**Re: *An Application for a CPCN for the Okanagan Transmission Reinforcement (OTR)  
Project No. 3698488 - ERRATA 2***

## **Okanagan Transmission Reinforcement Project**

### **ERRATA 2 to BCUC IR1 (Exhibit B-3)**

**Figure A17.1**

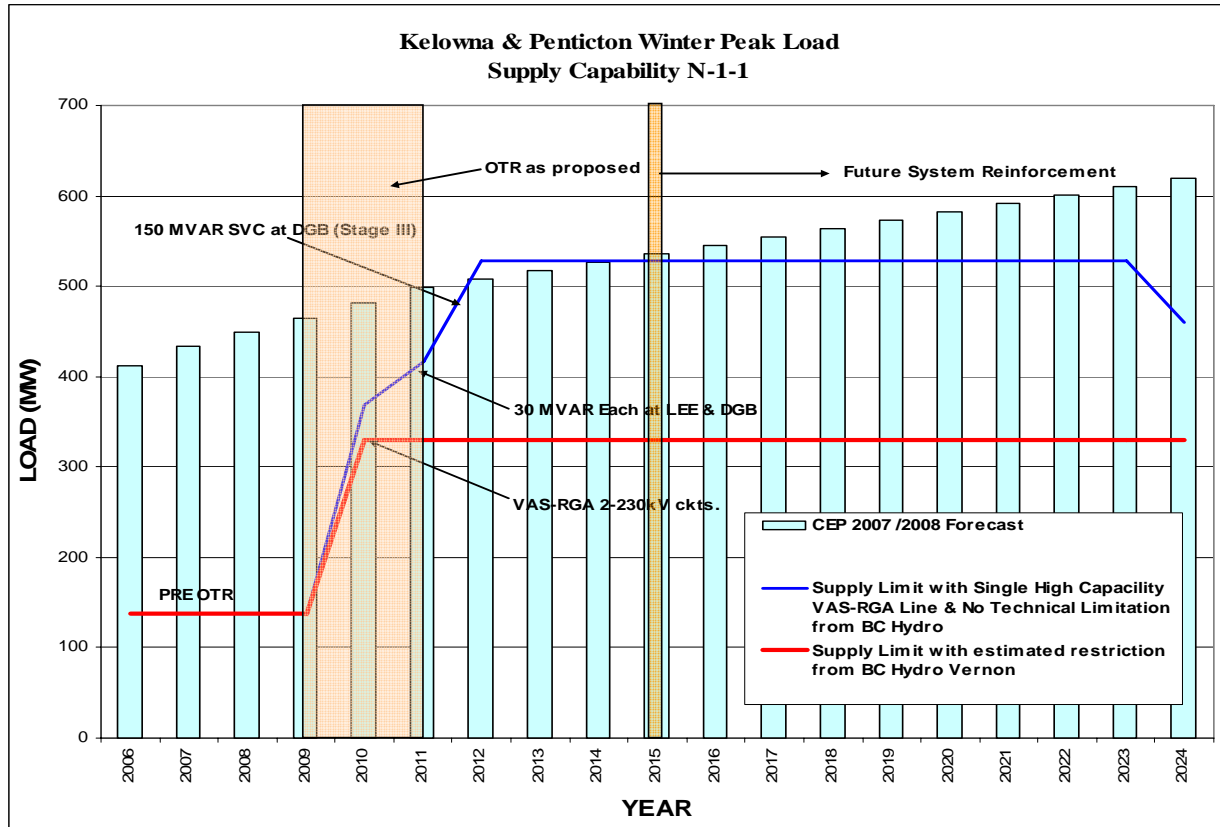
In the response to BCUC IR1 Q17.1 the reference to a “dashed” line should have read “solid blue” line.

The legend in Figure A17.1 should have read “Supply Limit with single High Capacity VAS-RGA Line & No Technical Limitation from BC Hydro”. The additional word “Vernon” was mentioned in error.
